**Table ES1. Review of Pebble Limited Partnership’s (PLP’s) Environmental Baseline Document (EBD): Hydrologic characterization**

**Figure 1. Water balance results for SK100F.** Note that there is general correspondence between the water balance predicted and observed flows.

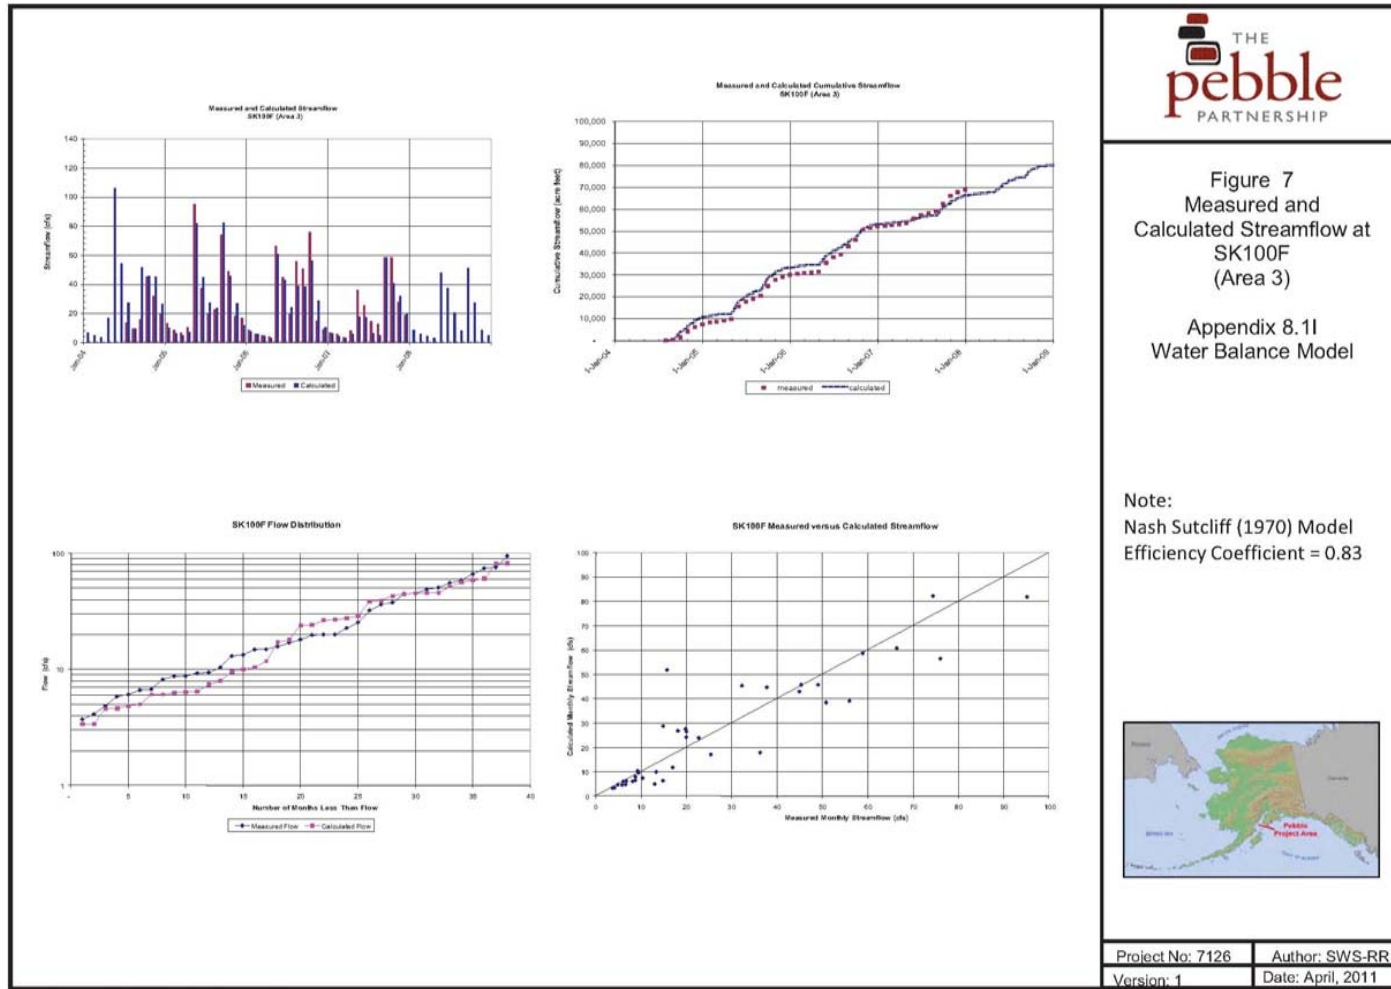
Chapter 8 of the EBD presents the water balance and numerical hydrologic models that PLP has developed to simulate baseline conditions at Pebble. These hydrologic models are presented in a way that gives the impression of a well-characterized hydrologic system. Monthly flows are well approximated by the water balance model, and spatial and temporal patterns of flow are matched by the numerical groundwater model (Figure 1). However, when the components of these models are examined in detail, it is questionable whether PLP actually has an adequate understanding of the hydrologic system. Examples of these shortcomings are described below.

Despite an extensive hydrologic data collection program, the only measured parameters used in the water balance are streamflow and groundwater elevations. All other variables are adjusted so that the remaining inputs and outputs to the hydrologic system match these parameters. From Chapter 8, page 26 of the EBD:

Using this method, the modeled inputs and outputs to the hydrologic system are essentially guaranteed to balance, as presented in Appendix 8.1I. However, given the mismatch between *measured precipitation* and *measured streamflow* as described above, it is questionable whether this calibrated water balance paints a realistic picture of the hydrologic system. The water balance model requires between 40 and 55 in. per year of annual precipitation (an amount that varies by sub-catchment) in order to supply enough water to the system to match the measured streamflow. Yet the measured annual precipitation over the three years of monitoring is only 30–39 in. (EBD, Chapter 2). Thus, either the measured precipitation at the site is 25–40% too low or the measured streamflow at the site is 25–40% too high. It is nearly impossible to tell based on existing data which of these errors underlies the hydrologic imbalance at the site. However, given the magnitude of the discrepancy, it is clear that PLP must resolve this issue.

**Figure 2. Comparison of field-measured hydraulic conductivity values to values used in PLP's groundwater model.**

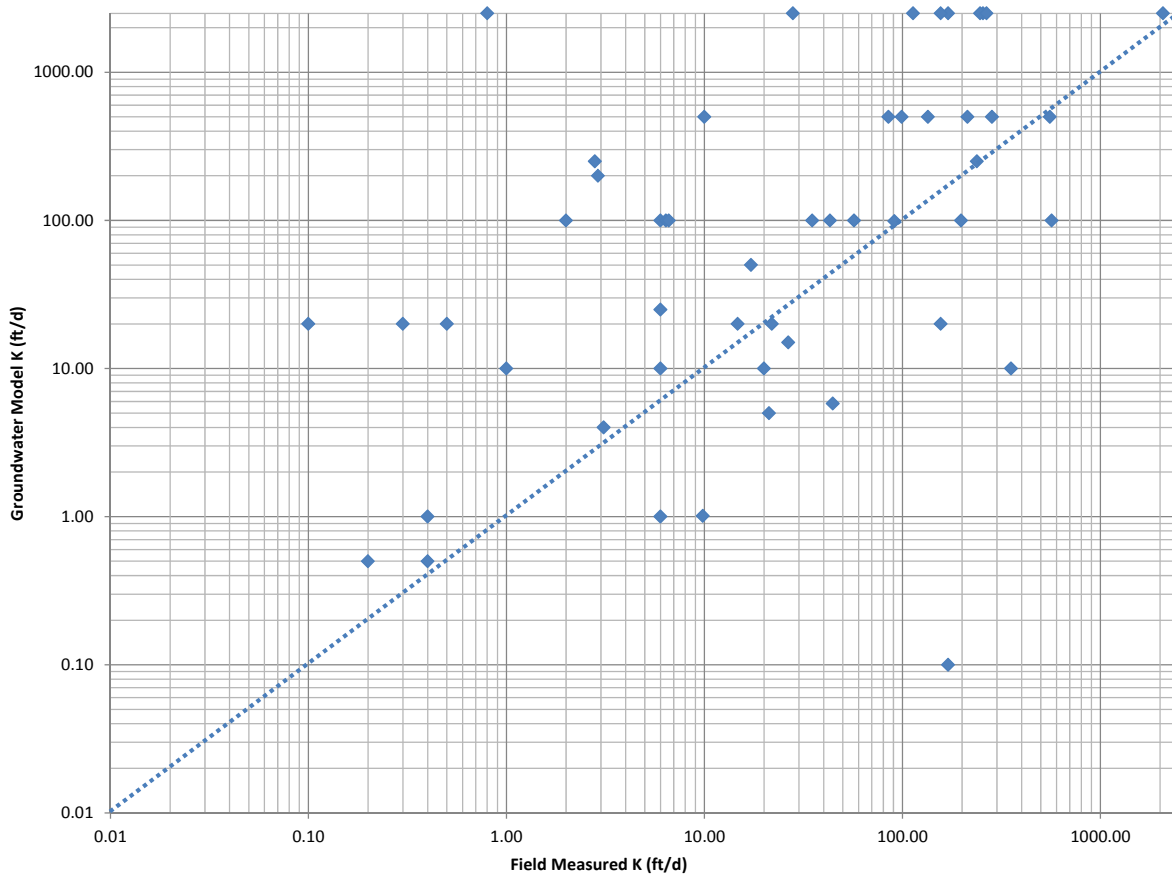
The remainder of Appendix 8.1J presents the results of the numerical groundwater model calibration, reporting statistics on goodness-of-fit, root-mean-square (RMS) errors, etc. However, these calibration statistics reflect the correspondence between the numerical groundwater model and a flawed water balance because *measured precipitation* is too low to explain *measured streamflow*, as described above. In addition, the numerical groundwater model is over-parameterized relative to the amount of data available. The model domain is broken into 644 hydraulic conductivity “zones,” for which the hydraulic conductivity values used in the model have little to no relationship with field-measured conductivities. For example, Figure 2 is a plot of the hydraulic conductivity values used in the groundwater model vs. field-measured hydraulic conductivities. In general, the model values do not correspond at all to the field-measured values, indicating that the calibrated groundwater model ignores field-measured data.

Thus, while the EBD presents a numerical model that appears to be well-calibrated, the number of parameters and the values required to achieve this calibration often have little relation to field-measured data. This could have significant implications when using this calibrated model to evaluate changes in hydrology related to mining. In particular, since the model inputs are not true to available site data, the model may have no predictive capability at all when used for impact analysis (U.S. EPA, 2003).

**Figure 3. Hydraulic heads (piezometric levels) measured across ZE fault.** Note significant change in head across the ZE fault (~ 1,500 ft), demonstrating the control of this fault on groundwater flow.

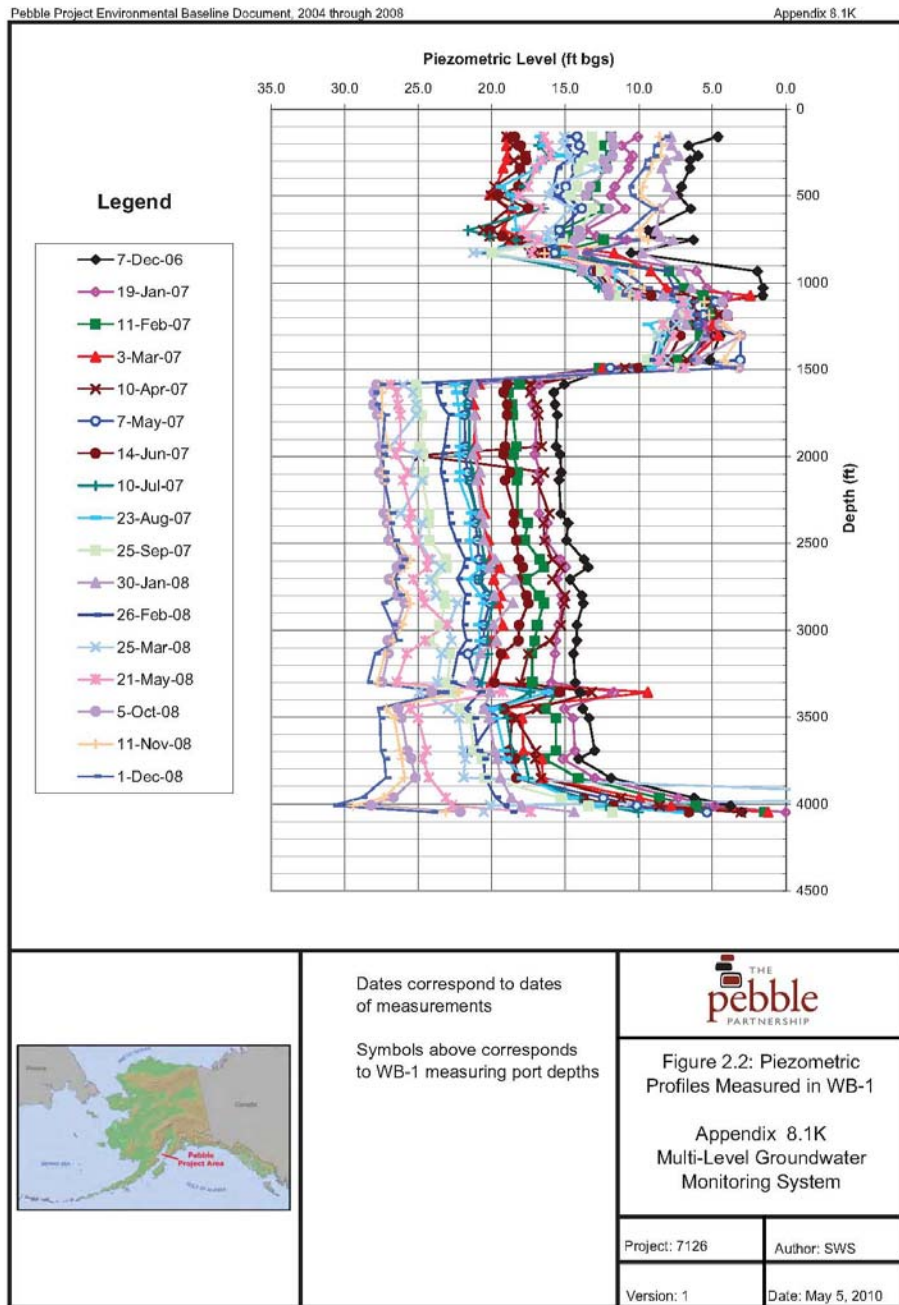
Third, the groundwater model does not incorporate the influence of faults on bedrock groundwater flow. The available data from tests in deep boreholes indicate that at least one of the major identified faults crossing the deposit area (the “ZE Fault”) exerts a strong control on groundwater flow: hydraulic heads rise approximately 20 ft across this fault, which indicates that groundwater is under pressure beneath this fault zone (Figure 3). This fault and other deep bedrock faults that would be intersected by a pit are clearly influencing groundwater around the deposit area, and could be conduits for groundwater flow. This suggests that these faults could make it difficult to maintain a capture zone around the pit both during and after mining. As currently presented, the groundwater model makes no mention of faults at all, calling into question PLP’s ability to predict the impacts of mining on groundwater. PLP must model the influence of major faults on groundwater flow, particularly near the pit where they could represent conduits for contamination to escape to downgradient surface water and groundwater resources.
